SB-10054910-9378**FORD:**

2013-2014 Escape

ISSUE

Figure 1 - Article 14-0004

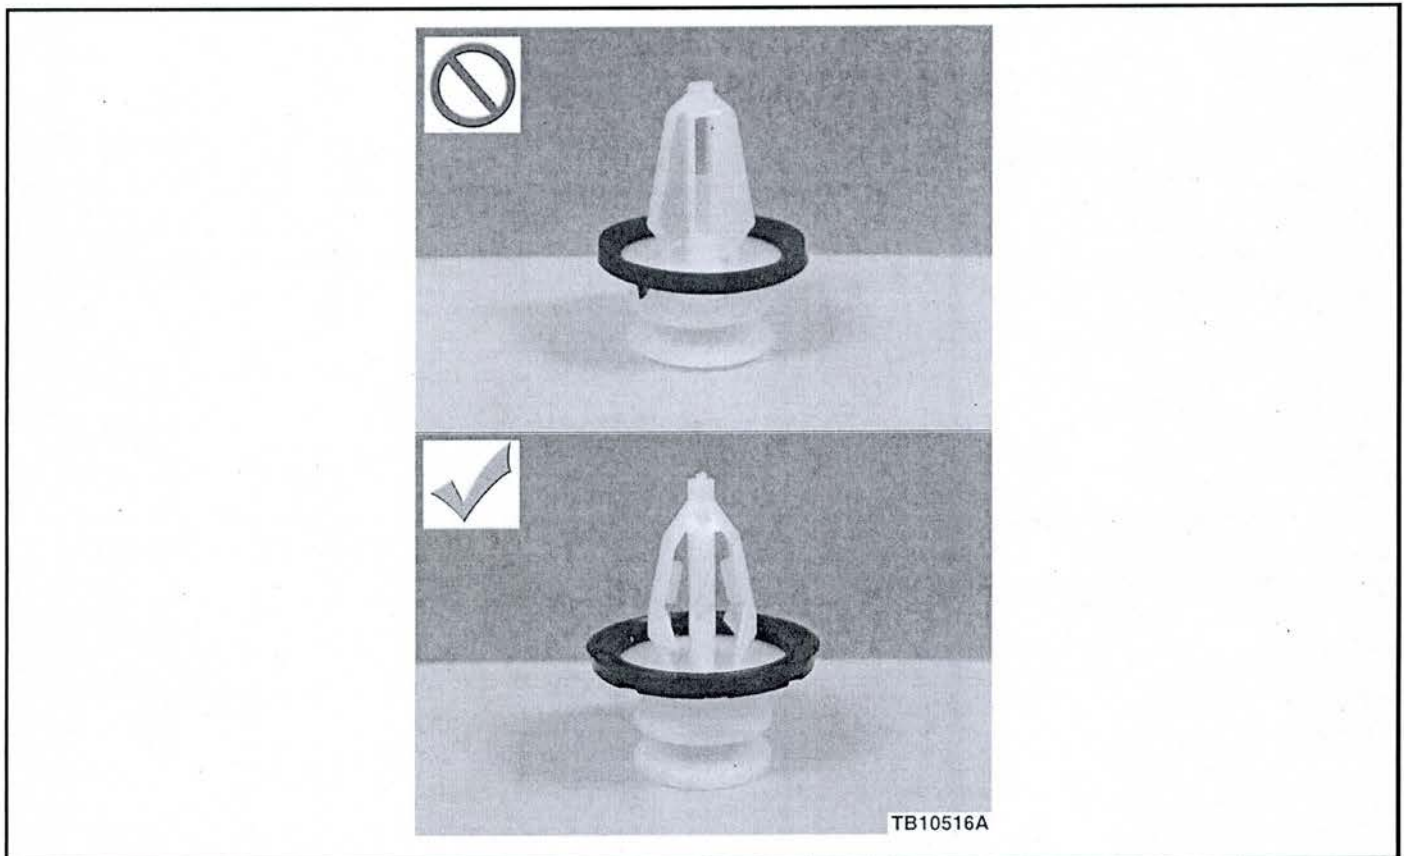
Some 2013-2014 Escape vehicles built on or before 9/13/2013 may exhibit loose attachment of the left or right rear door trim panel, typically near the bottom of the door. A new retaining clip is now available for service.

1. Is the affected rear door trim panel damaged as a result of the loose attachment?
 - a. Yes - replace the rear door trim panel. Refer to Workshop Manual (WSM), Section 501-05. Use new style retaining clips on new door panel. (Figure 1) Repair is complete.

- b. No - proceed to Step 2.
2. Remove the affected rear door trim panel. Refer to WSM, Section 501-05.
3. Remove the seven retaining clips from the rear door trim panel and discard.

4. Install the new retaining clips into the holes in the door trim panel.
 - a. When retaining clip is inserted in the correct position a clicking noise can be heard.
5. Install the rear door trim panel. Refer to WSM, Section 501-05.
